ADDENDUM TO BID DOCUMENTS

Ventura Unified School District

ATLAS Classrooms 2 and 3 Conversion:

Addendum 1
DATE: March 28, 2022

A-4.0

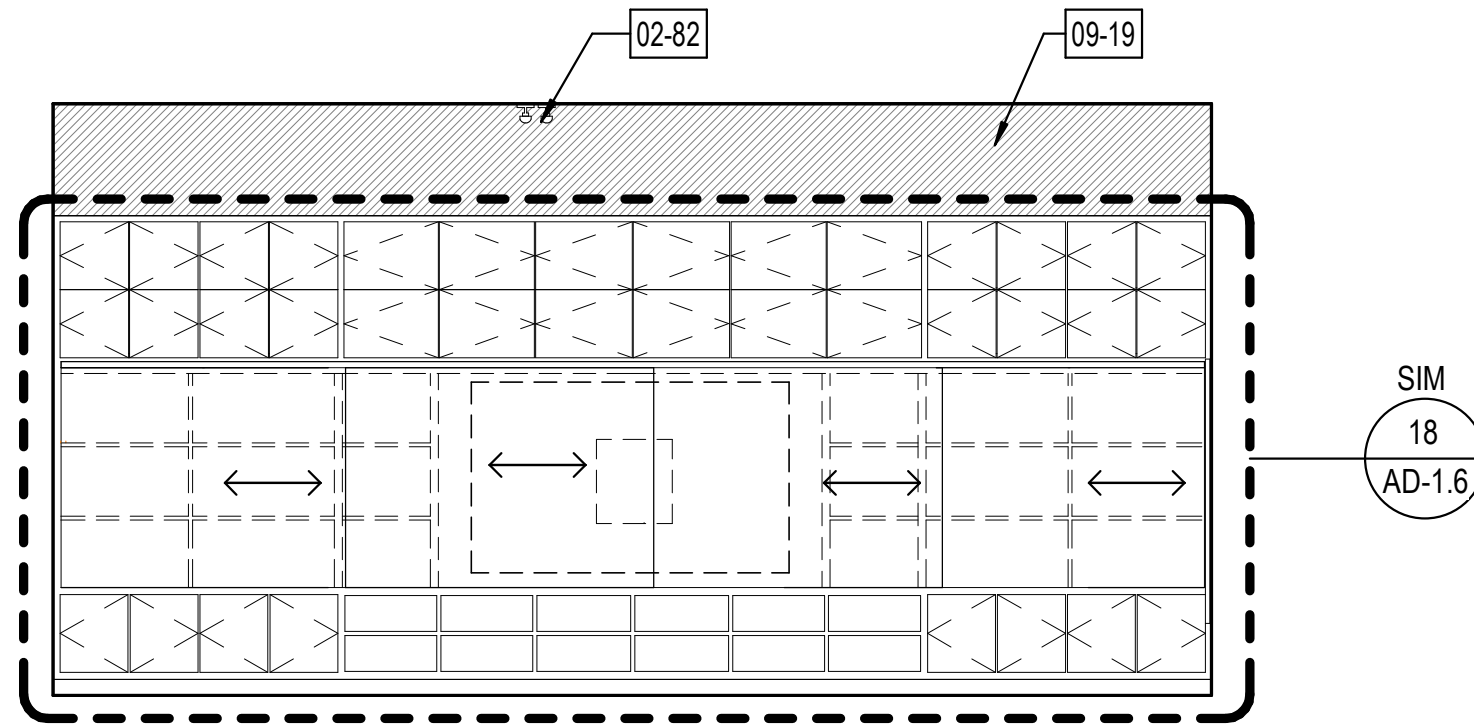
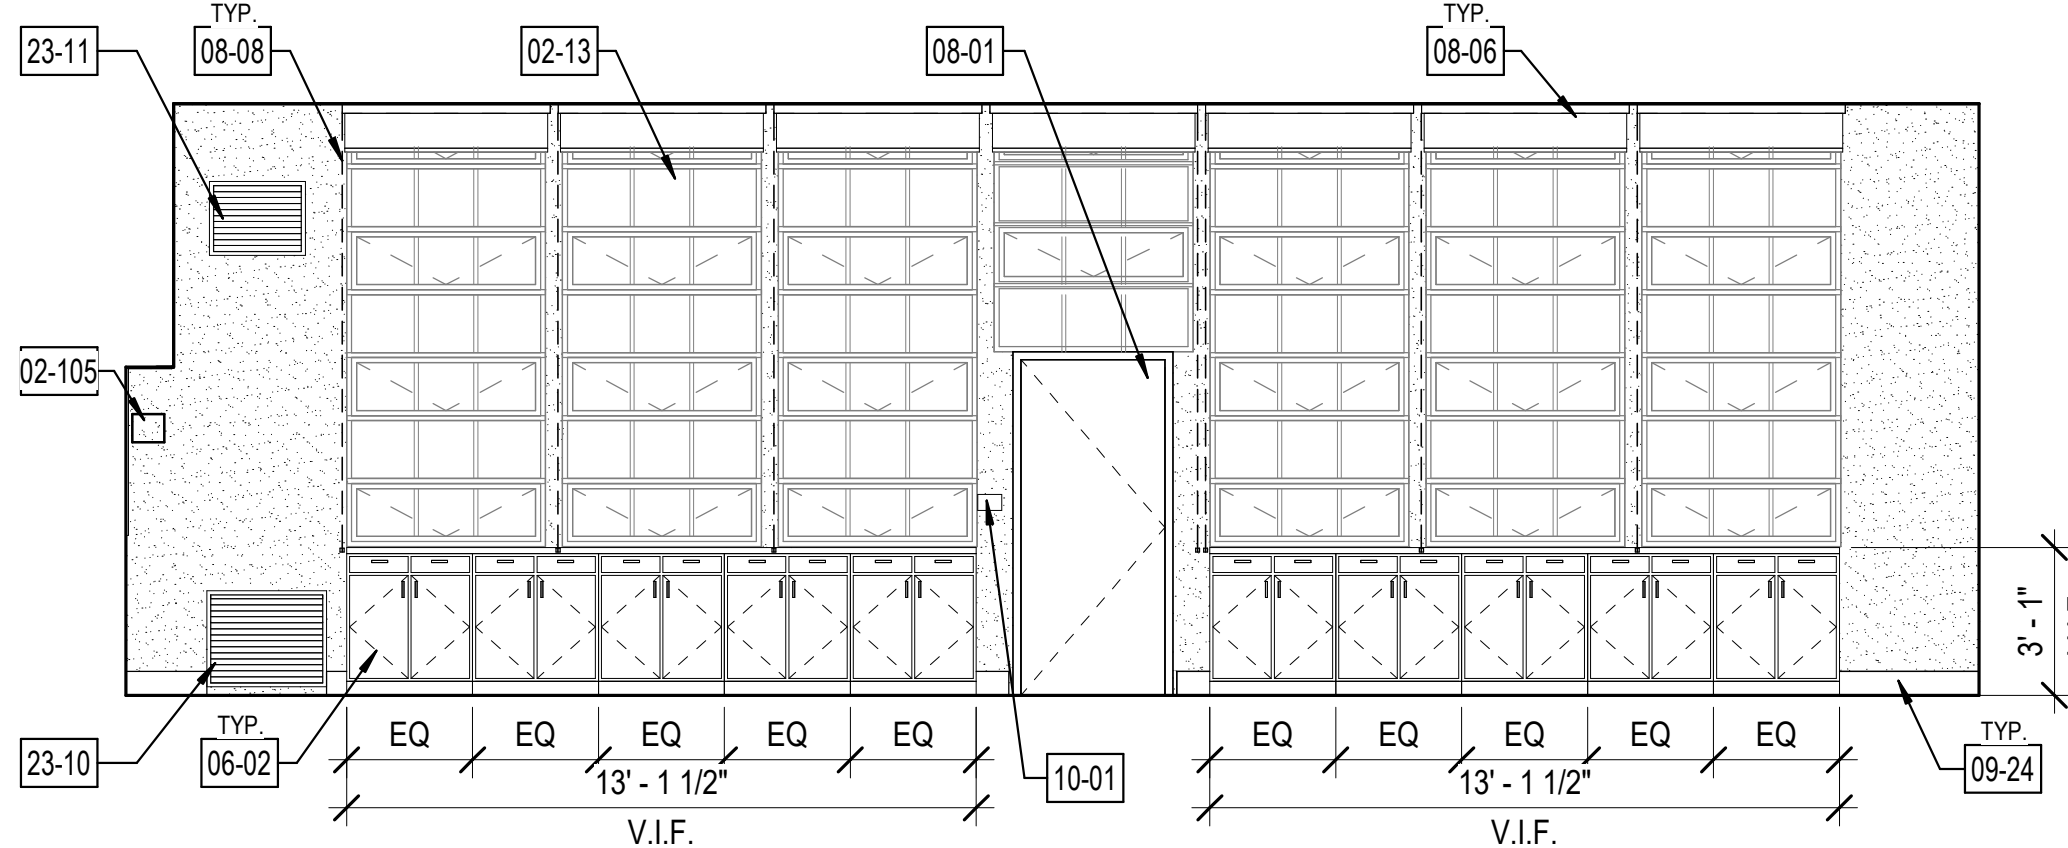
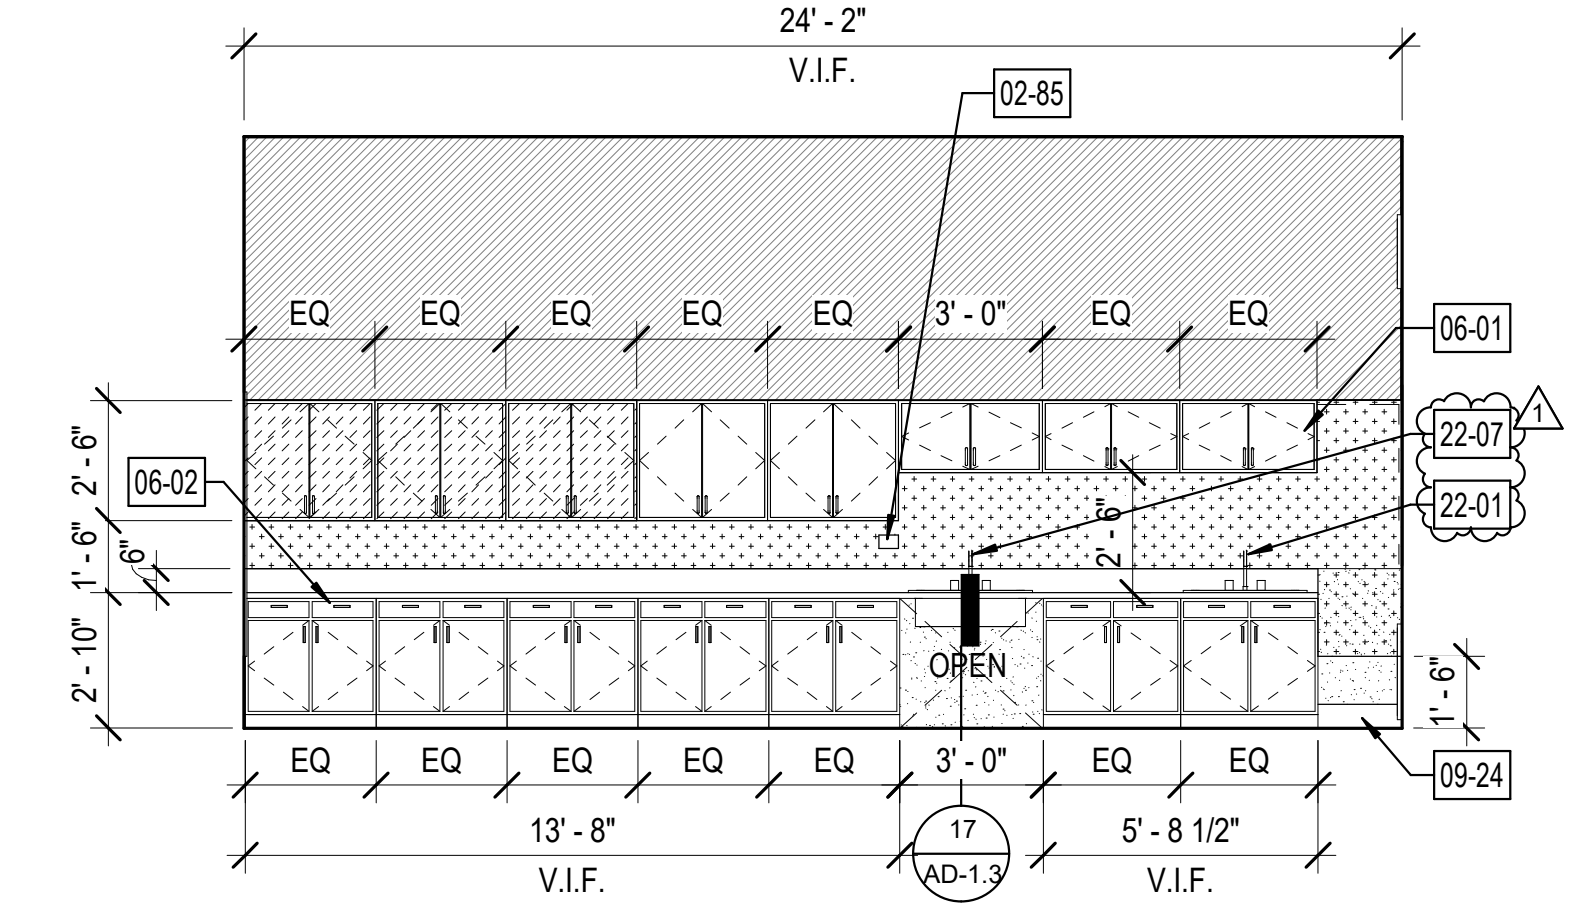
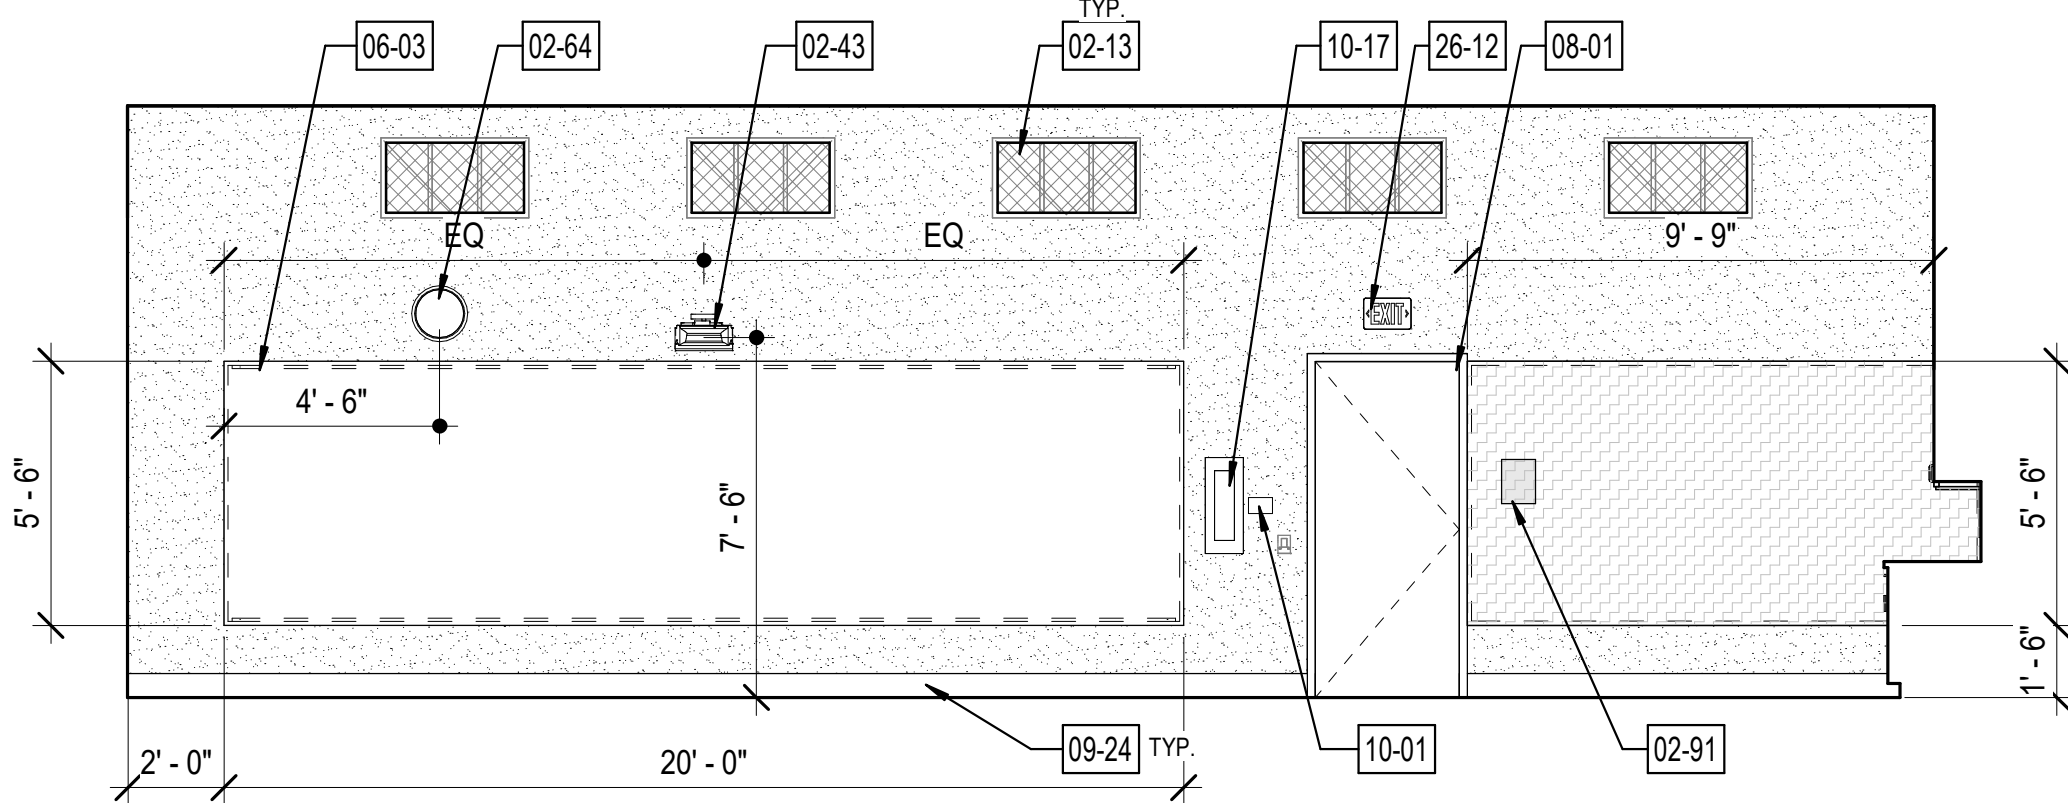
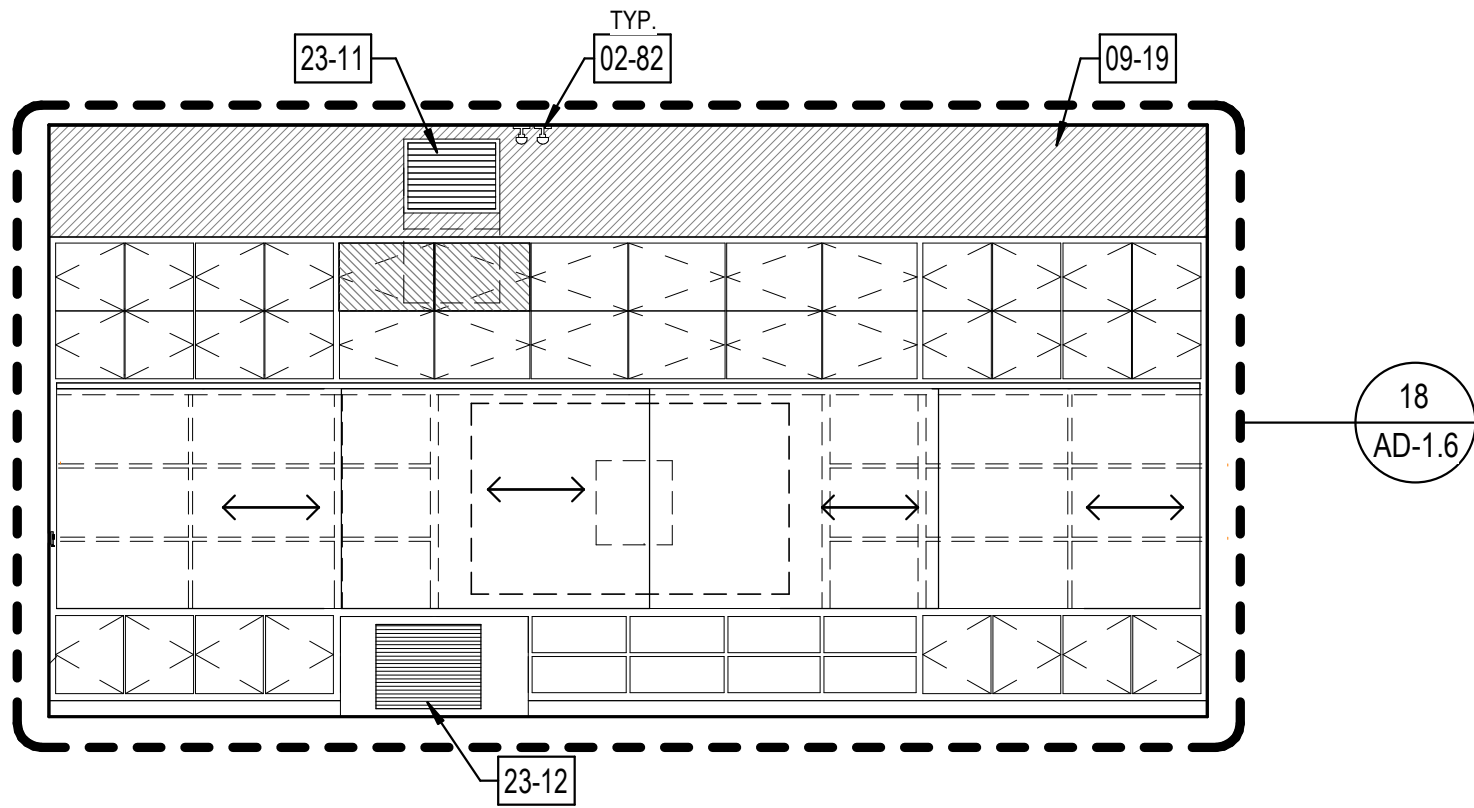
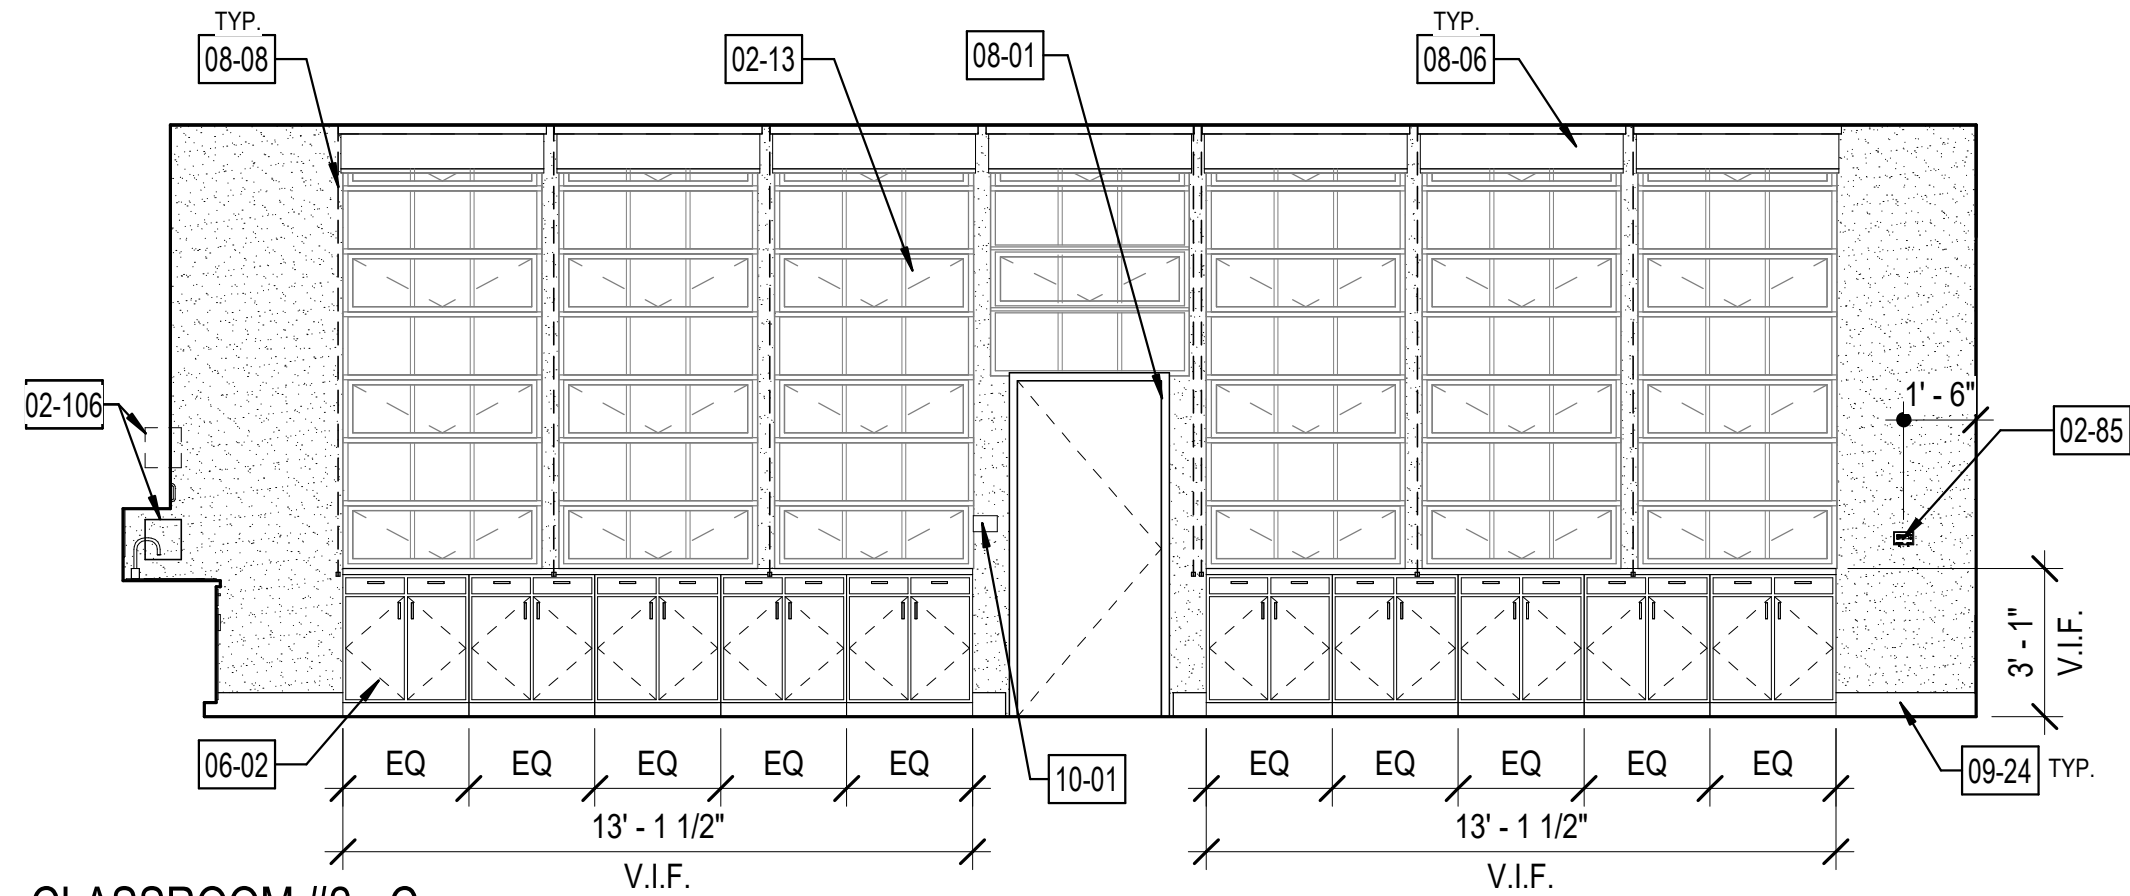
Item 4: Sheet A-4.0 INTERIOR ELEVATIONS

- Revised Keynote 22-01.
- Switched keynotes 22-07 and 22-01.

RFI #004**Question:**

A-4.0 - Legend calls for level 4 finish while the keynote 09-19 calls for level 5, please confirm decal wall finish level.

RFI #005**Question:**

A-4.0 - Please confirm location of decal, note 09-19 is on the small soffit (details 4/8). Existing classrooms has decal on larger soffit (details 2/6).

RFI #006**Question:**

A-4.0 - Details 2/6 show cabinet doors under sink, however keynote 22-07 refers to detail 17/AD-1.3 which shows ADA accessible sink. Please confirm.

RFI #007**Question:**

A-4.0 - Keynote 22-01 show sink open below and references detail 11/AD-1.5. Please confirm this location does not use detail 17/AD-1.3.

Answer:

Legend on sheet A-4.0 revised to show level 5 finish.

Answer:

Both soffits are to be level 5 finish in both classrooms. Decal is to be owner furnished, owner installed. Legend on interior elevations have been revised to level 5 finish.

Answer:

Only 1 sink will have doors. Keynote 22-01 has been revised. Location of keynotes 22-07 and 22-01 switched on interior elevations 2 and 6 on sheet a-4.0.

Answer:

The sinks closer to the south wall in both classrooms will have cabinet doors. Keynote 22-01 updated. Location of keynotes 22-07 and 22-01 switched on interior elevations 2 and 6 on sheet a-4.0.

A-5.0

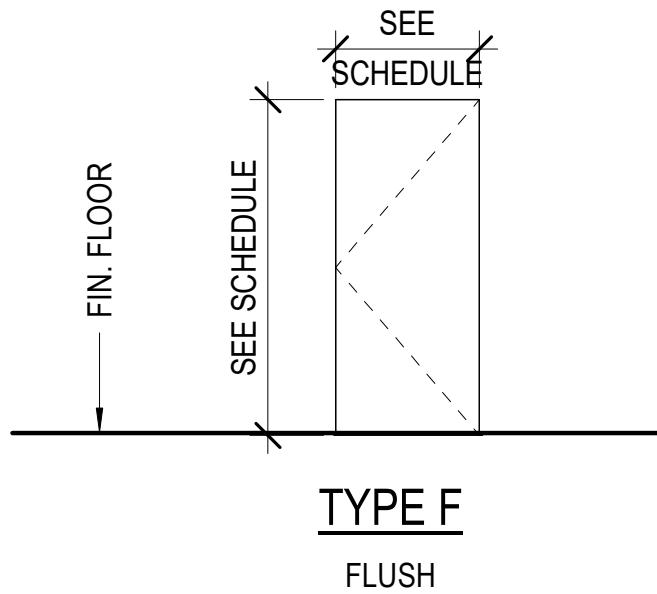
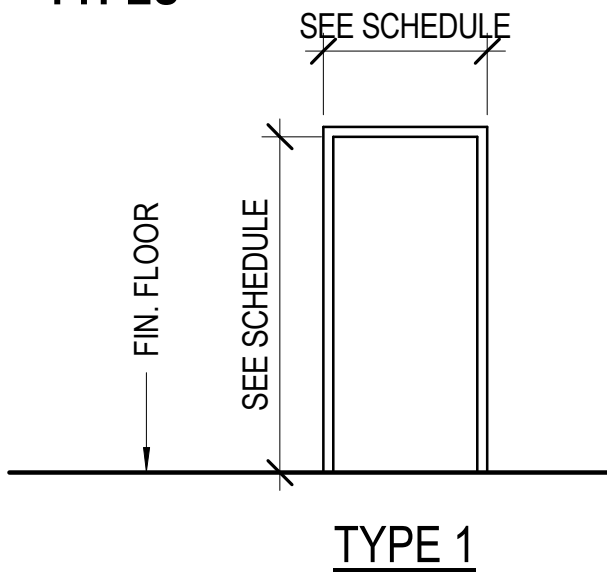
Item 5: Sheet A-5.0 DOOR & FINISH SCHEDULE

- Corrected "ACP 1" label in finish schedule to match specifications.
- Added remark #3 to door schedule and to legend.
- Size of doors 102.2 and 103.2 updated to be 3'-0" X 7'-0"

RFI #010**Question:**

A-5.0 - Existing doors are 3'0"x7'0", please confirm new doors sizes of 3'0"x7'0" and 3'6"x6'10".

Answer:

All (E) doors are 3'-0" x 7'-0" sizes; new doors will match existing. Revised door schedule to reflect 3'-0" x 7'-0". Remark #3 has been added on door legend and door schedule on sheet A-5.0.
